Donald C. Cook Nuclear Plant Units 1 and 2  
STEAM GENERATOR INSPECTION – REQUEST FOR ADDITIONAL  
INFORMATION (TAC NOS. MB8121 and MB8122)

ATTACHMENT TO AEP:NRC:3691-05

**Steam Generator Inspections  
Request for Additional Information**

Figure 1  
Unit 1 Steam Generator

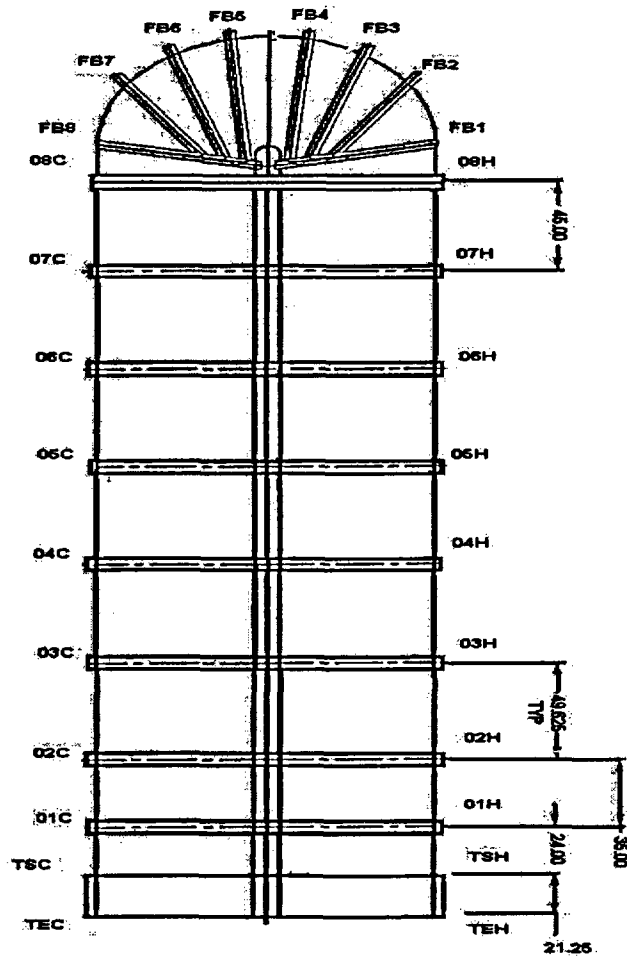
In several locations in your reports, reference is made to tube support structures (e.g., fan bar 5) and tube locations (e.g., R53/C53). In order for the staff to better understand the location of the indications and the tubes, please provide (1) sketches of the Unit 1 and 2 steam generators that depict the tube support naming conventions and (2) tubesheet maps that depict the rows and columns of the tubes. In addition, please provide a general description of the replacement steam generators for both Units 1 and 2. Include in this general description the total number of tubes, tube diameter, tube wall thickness, tube material, tube pitch, tube support (including fan bar/anti-vibration bar) material and configuration (e.g., quatrefoil broached hole), tube support thickness, tube manufacturer, steam generator manufacturer, tubesheet expansion method (e.g., hydraulic) and any other noteworthy design characteristics from a steam generator tube integrity standpoint (e.g., full length stress relief of the row 1 through row 10 tubes). In addition, discuss whether measurements from a tube support are from the middle of the support or the edge of the support (e.g., does fan bar 5 plus 0.61 inches, indicate an indication 0.61 inches from the top edge of the fan bar).

Schematics of the Unit 1 and Unit 2 steam generators are provided in Figures 1 and 3, respectively. Diagrams of the Unit 1 and Unit 2 tubesheets are provided in Figures 2 and 4, respectively. Table 1 provides the details of the Unit 1 steam generator, and Table 2 provides the details of the Unit 2 steam generator.

The convention for providing tube locations is to measure from the middle of the tube support. Thus, the location 05H + 0.50 is 0.50 inches above the middle of the fifth tube support on the tube hot leg side.

Figure 5  
Unit 1 Bobbin Voltage Amplitude Distribution

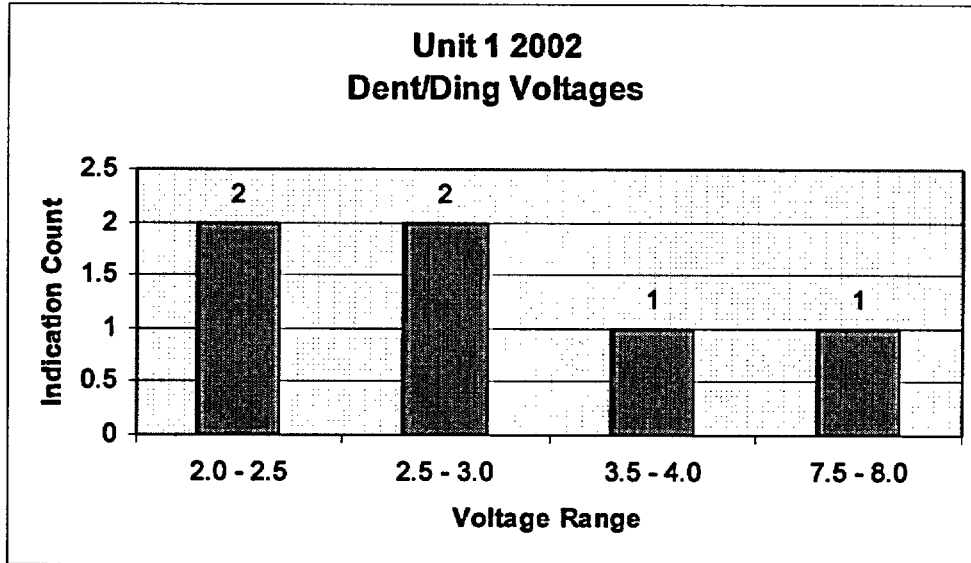
For both Units 1 and 2 there were a number of steam generator dents and dings reported. Please provide the bobbin voltage amplitudes for these dents and dings (a graph depicting the distribution of amplitudes is acceptable). In addition, discuss whether these dents/dings were present since the baseline inspection. If the dents/dings were not present since the baseline inspection, discuss the possible root cause. For Unit 1, only one of the 6 dents/dings was examined by a rotating probe. Please discuss the basis for selecting this one indication for rotating probe testing. For Unit 2, 20 percent of the dents/dings were tested with a rotating probe. Please discuss how the 20 percent sample was selected (e.g., random, all indications above 5 volts with a random sample below 5 volts, etc.). Please discuss whether the method used to size the dents/dings is consistent with standard industry practice (alternatively provide a summary of the calibration method).

The bobbin voltage amplitude distributions for the dent/ding signals reported during the 2002 inspection are presented in Figure 5.

A review of the Unit 1 data noted that of the six indications, five were present in the baseline examination record and had not changed. The sixth tube, SG 14, R34/C26, was found to have a small ding indication (2.15 volts) in the U-bend region that was not present in the baseline data. This indication was most likely caused by either probe interaction when traversing the U-bend region or by steam generator movement during shipping (Note: The baseline examination was performed in the factory and no additional inspections were performed until 2002).

Figure 7  
 Decision Flowchart

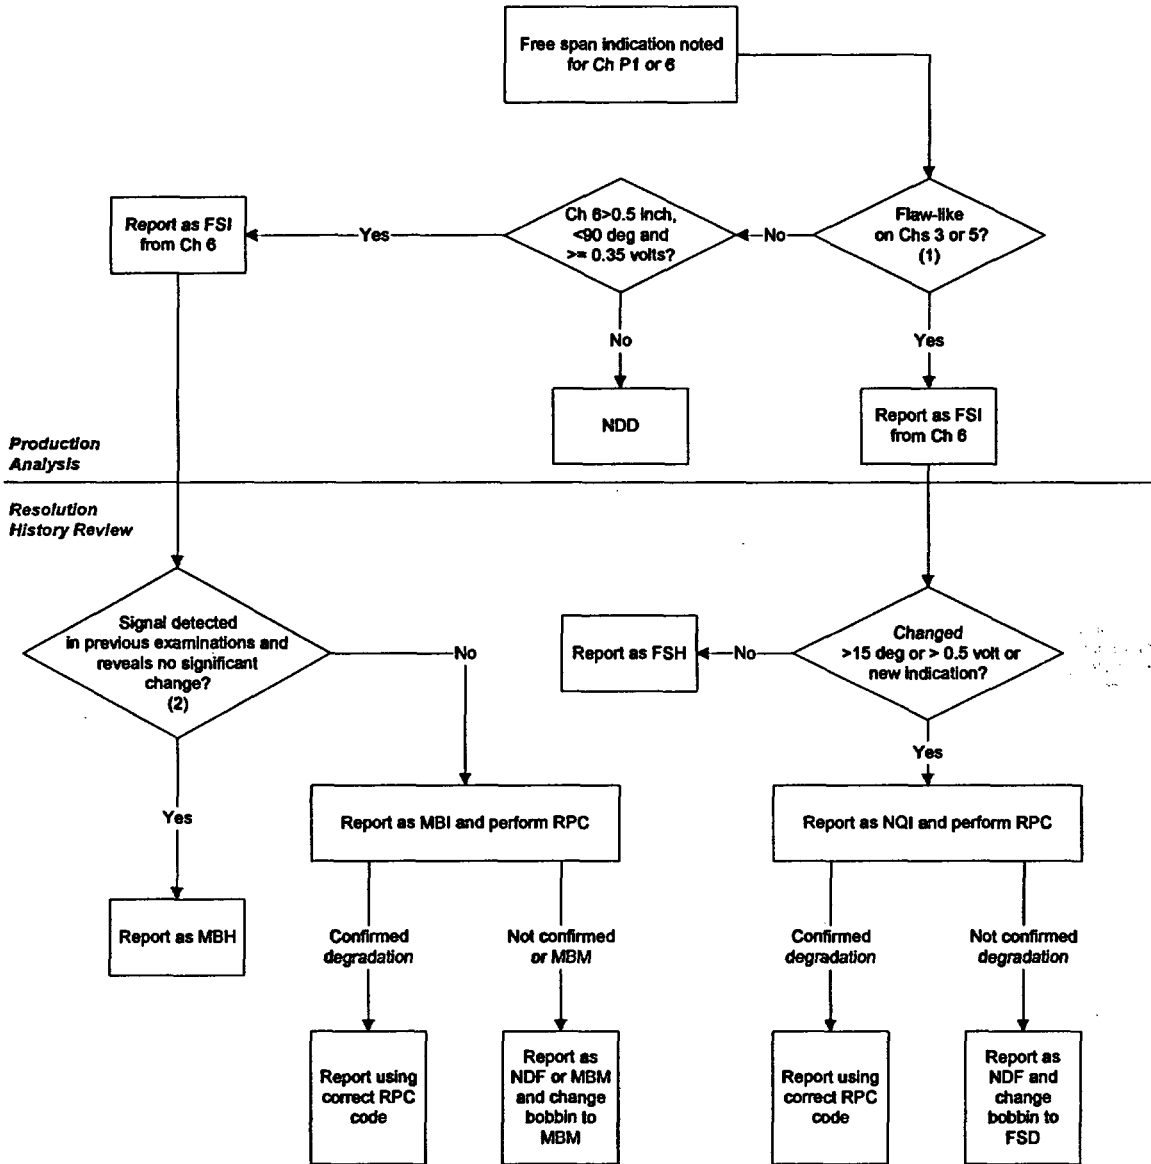
Four tubes in Unit 1 were plugged because of signal amplitude changes (1.0 to 2.5 volts) associated with MBMs/MBIs/MBHs. The MBIs were determined to have arisen from tube buffing operations during the manufacturing process after further investigation by EPRI. Although the indications may have been attributed to manufacturing, it is not clear why the signal amplitudes changed. Please provide a summary of your root cause analysis for why the indications changed in amplitude (or a description of what actions you may be planning to take to investigate the reason for the amplitude change). Please discuss whether any additional diagnostic testing was performed on these indications (e.g., ultrasonic testing, in-situ pressure testing, tube pulls, etc.). For the criteria used to determine if a manufacturing signal exhibits little or no change, discuss how the criteria was determined (e.g., was test repeatability evaluated for these types of indications such that the criteria would identify a signal change when the change was greater than normal test repeatability).

The criteria for determining whether a signal had changed was developed by the lead level III analyst and concurred with by an independent level III analyst. The criteria, which are based upon industry experience, are illustrated in Figure 7.

(1) Flaw-like: reads above 0%  
 (2) Significant change: >15 degree positive phase shift. All MBH calls require review by both resolution analysts.
